**ORDINARY MEETING OF COUNCIL
TO BE HELD ON TUESDAY, 14 JUNE 2005 AT 7.00PM
LEVEL 3, COUNCIL CHAMBERS**

GB.1 1 to 9 Woniora Avenue, Wahroonga

To address matters raised at the site inspection of 14 May 2005 and for Council to determine a development application for the demolition of the existing structures on site and construction of 58 dwellings within three separate buildings; associated access, basement parking and landscaping and strata subdivision.

DIAGRAM 2

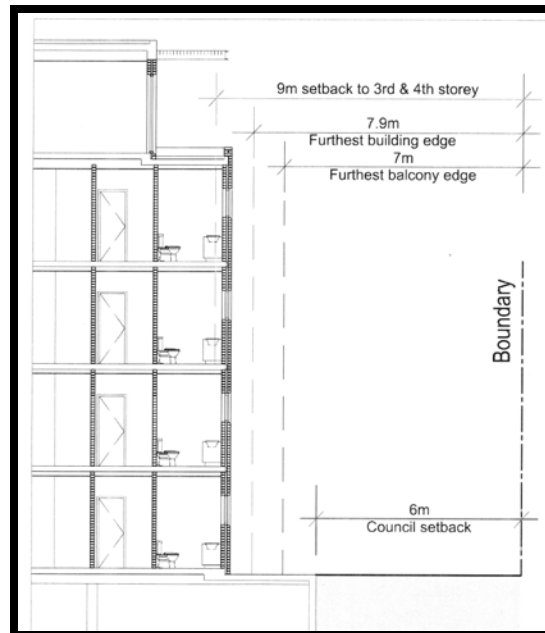
The proposal does not comply with the development standards prescribed in clause 25L(2) of Ku-ring-gai Planning Scheme Ordinance which requires that:

- a. The SEPP 1 objection prepared by Robinson Urban Planning Pty Ltd maintains that notwithstanding variation, the proposal satisfies the objective of the standard:
 - i. *“The non-complying elements do not adjoin any low density (detached) residential zones or development. The affected adjoining uses are:*
 - *An existing residential flat building at 18 Marian Street which is zoned 2(b) (Buildings 1 and 2)*
 - *The Marian Street car park which is zoned Special Uses.*

DIAGRAM 2A – Building 1 top floor setback to Marian Street

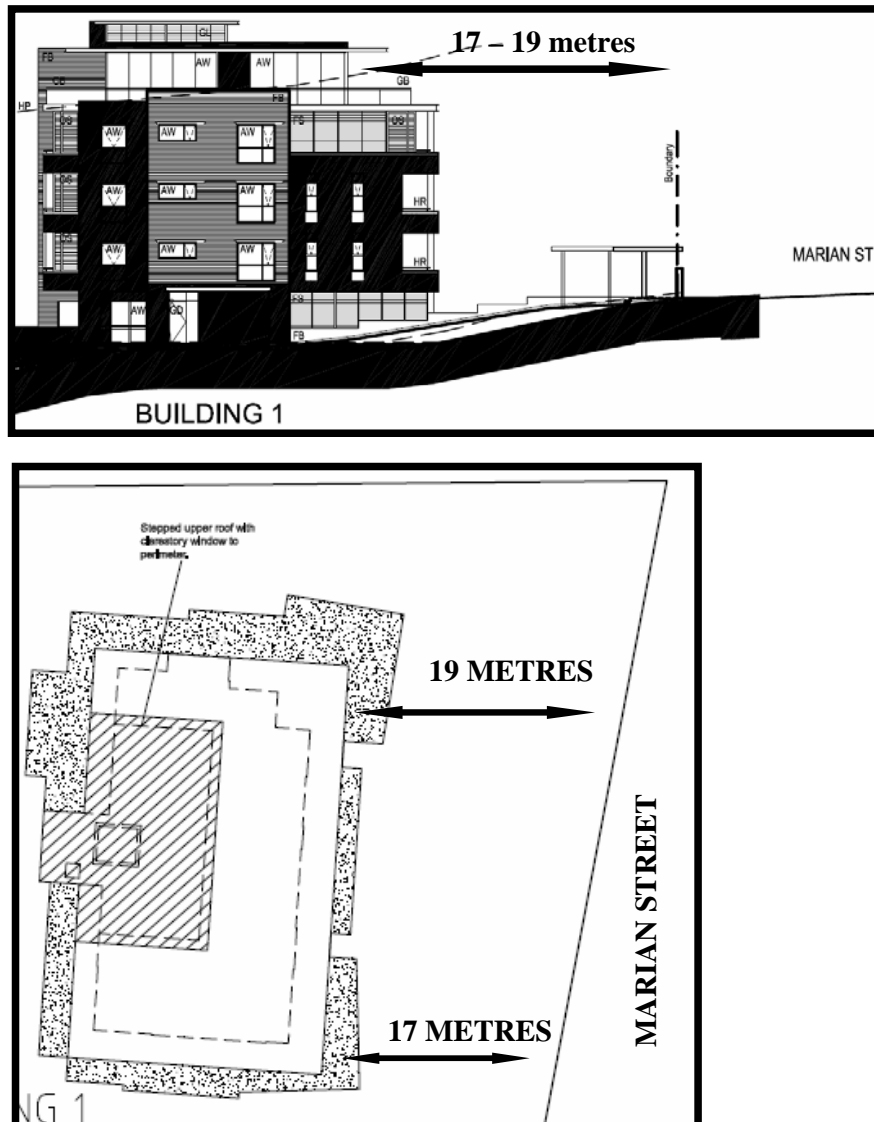
The setback of the 5th floor to the front boundary measures 17 metres at its closest point (eastern corner) and tapers to a maximum of more than 19 metres at its western corner as shown in Diagram 2a.

DIAGRAM 3 – Extent of the basement car park intrusion

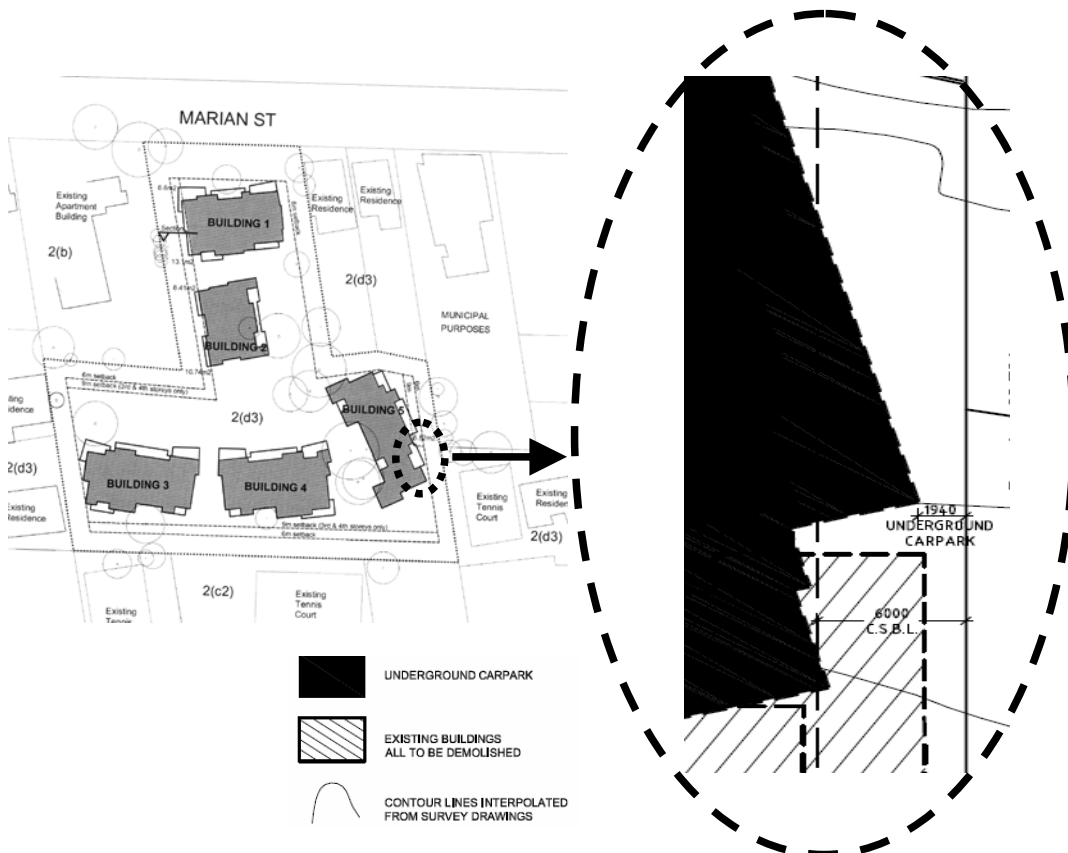
where the car park tapers to approximately 2 metres from the boundary. This 'pinch point' is acceptable in the circumstances as the building façade is compliant with minimum setbacks of 6 metres. Sufficient landscaping can also be established within this setback. It should also be noted that this only affects the proposed residential flat building at No's 6-8 Culworth Avenue (DA1369/04) currently under assessment and no objection has been received from the owners of that property.

DIAGRAM 4 – Changes to ground level in the vicinity of No. 8 Marian Street

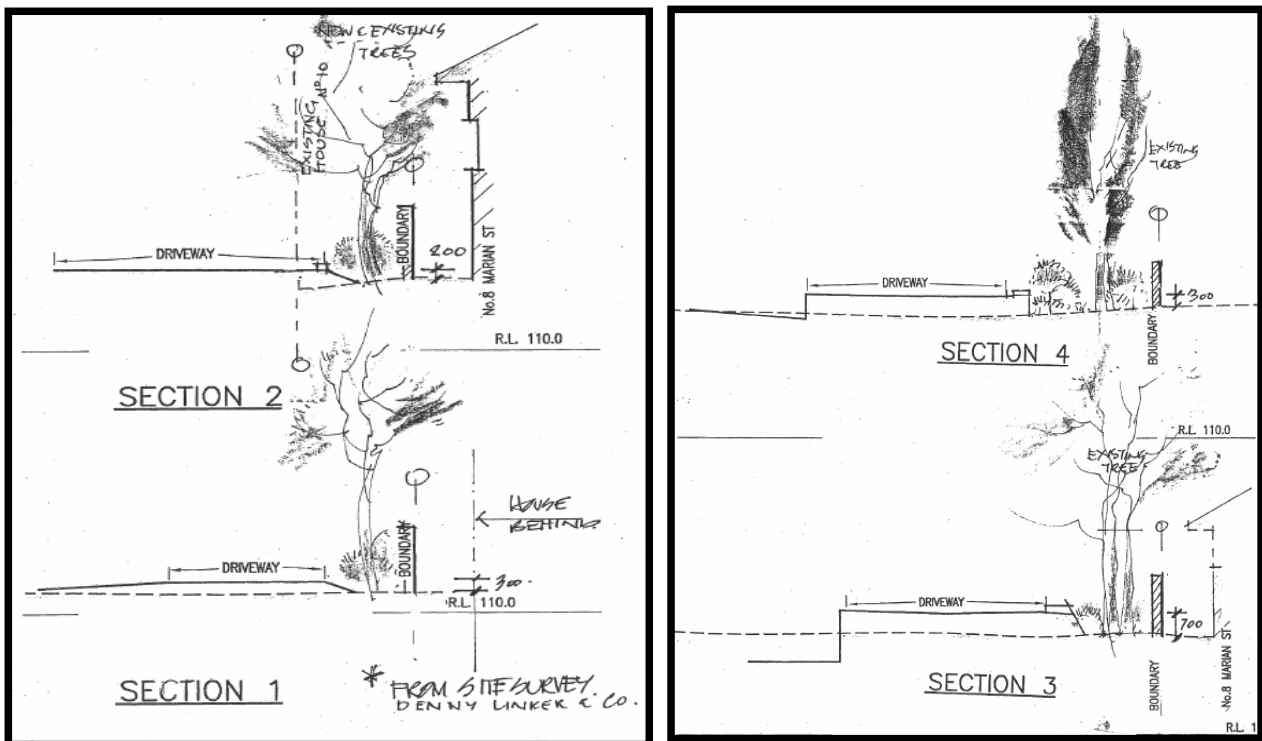
Diagram 4 below shows the extent of the ground level changes in the vicinity of the boundary with No. 8 Marian Street. The level changes vary from 300 to 700mm and are limited to the actual driveway only. No level changes are proposed in close proximity to the boundary line. Numerous trees are proposed to be retained in this area and these will be protected during construction (**refer Condition No’s 64 & 69**). To further protect the amenity of that property a stepped, 1.8 metres high, masonry wall will be constructed for a length of approximately 50 metres on the boundary as shown in Diagram 5.

Building 1
eastern façade
with fenestration
amendments

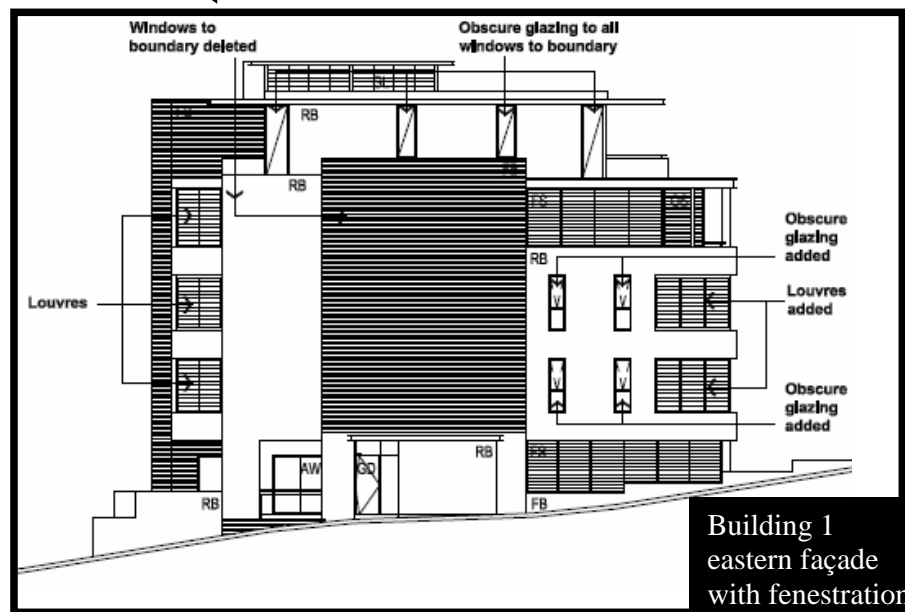
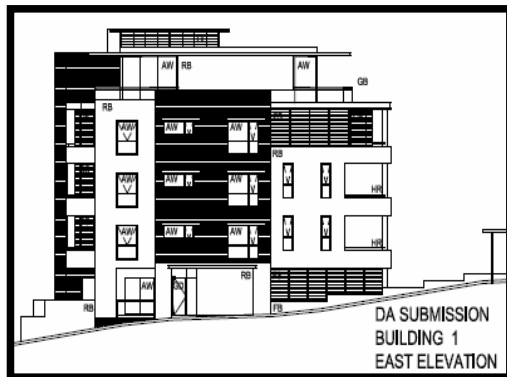
To further ameliorate the concerns of the residents at No. 8 Marian St, changes have been incorporated into the eastern façade of Building 1 to remove any potential cross viewing between Building 1 and No. 8 Marian St. This has been achieved by reducing the number of windows to Level 1 – 4 from 23 to 16; introducing additional louvres and using obscure glass. On Level 5, all

trafficable balconies are set back from the edge of the building, the number of windows is reduced to the east elevation and obscure glass introduced. These amendments are shown in Diagram 6 below.

DIAGRAM 6 – Separation to No.'s 22 and 22a Marian Street

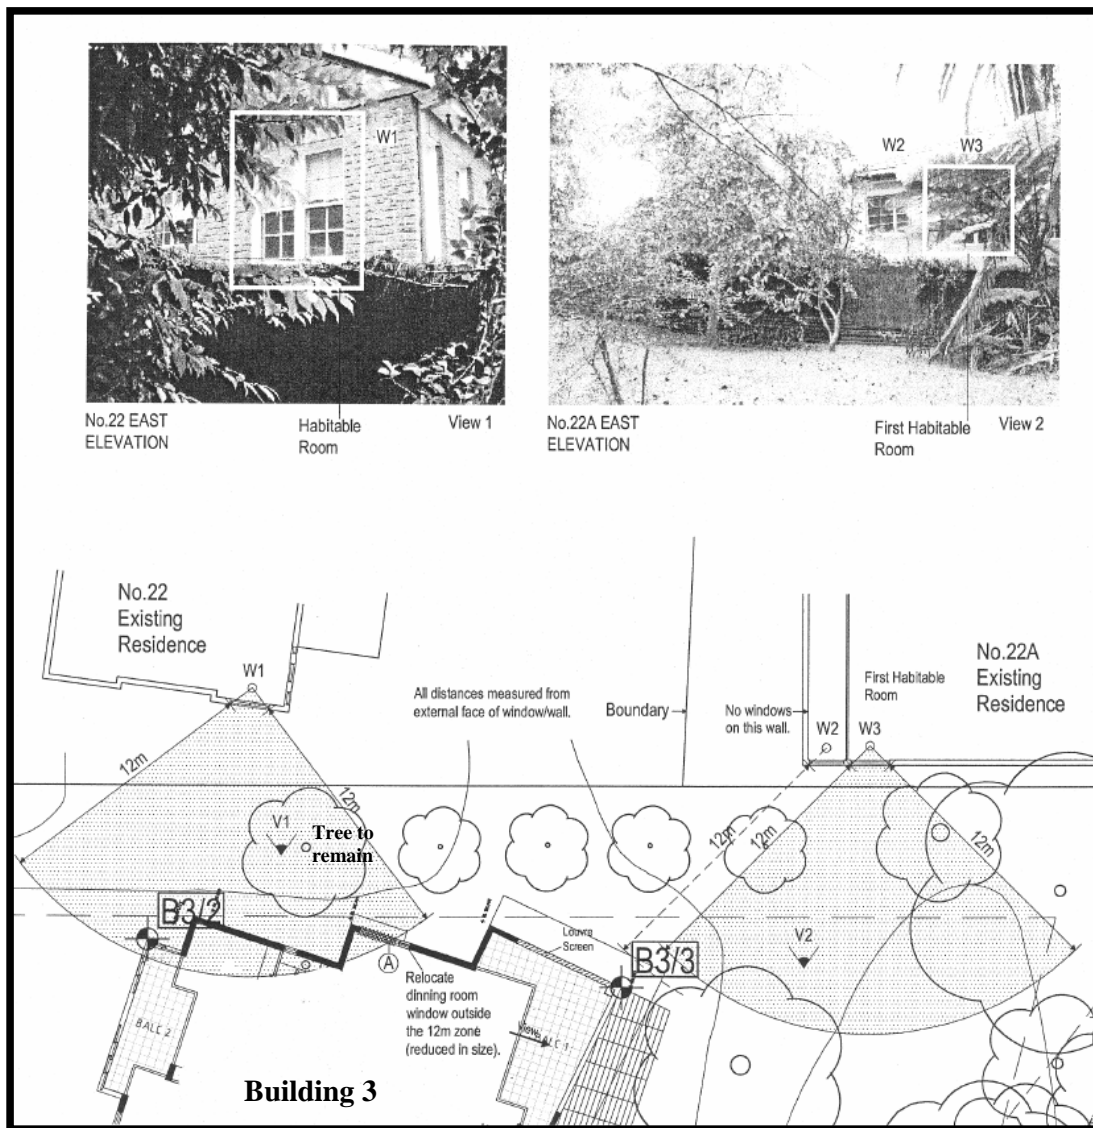
- 11. Staff are to clarify/confirm compliance with Council's setback controls specifically in relation to habitable rooms of adjoining properties along that part of the site adjoining No 22 and 22a Marian Street.**

22a Marian Street: Diagram 6 shows that habitable room windows (on Levels 1-4 of Building 3) are sited more than 12 metres from the adjoining dwelling at 22a Marian Street. Habitable rooms on the 5th floor are separated by more than 18 metres. The separation to No. 22a Marian Street therefore complies with the requirements of DCP 55 which requires 12 metres separation between habitable rooms (Levels 1 to 4) and 18 metres between habitable rooms on the 5th floor. The trafficable terrace area on the 5th Level is set back approximately 4 metres from the edge of the building in order to reduce overlooking of No's 22a and 22 Marian Street.

DIAGRAM 8 Fenestration as per the amended plans

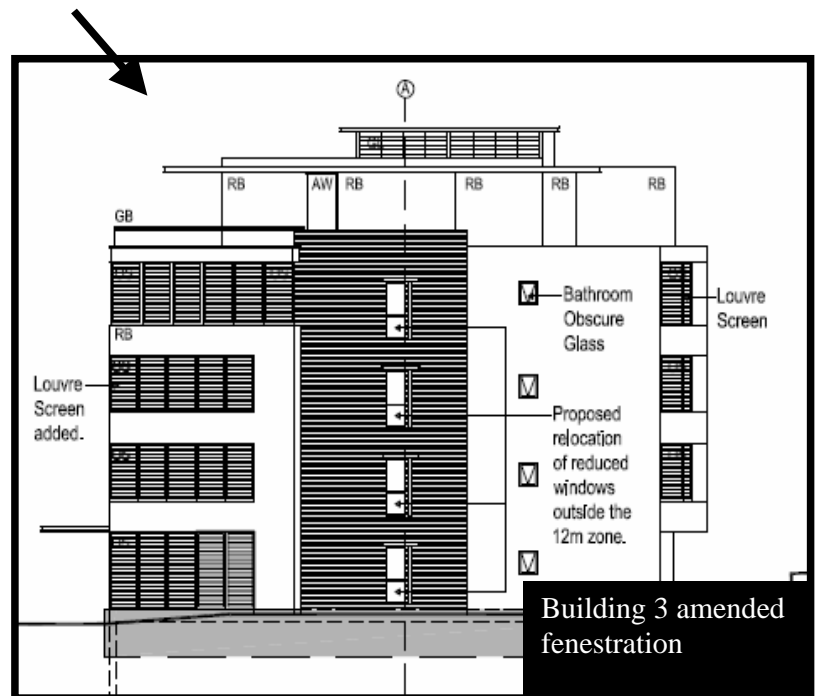
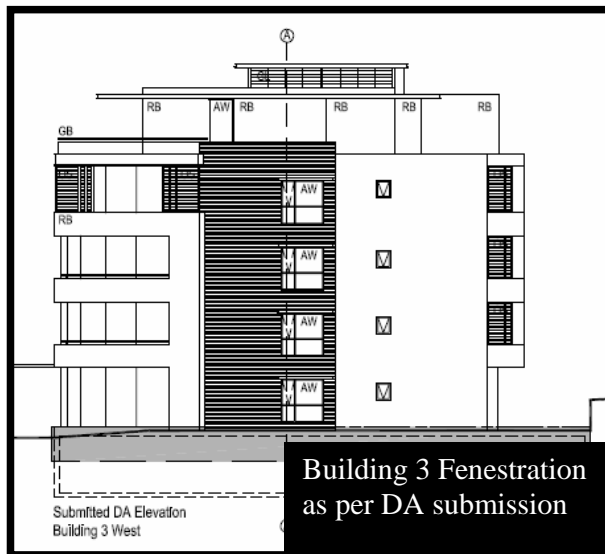
22 Marian Street: Diagram 7 below shows that the the proposed wall of Building 3 has limited fenestration: two windows (on each floor) facing west - one to the bathrooms and one to the dining rooms. Direct cross-view is also interrupted by an existing tree which is proposed to remain (shown in Diagram 6 above).

- b. The dining room windows are orientated away from the window at 22 Marian Street but are also reduced in size and relocated outside of the 12 metres zone (as shown by Diagrams 3 and 8).
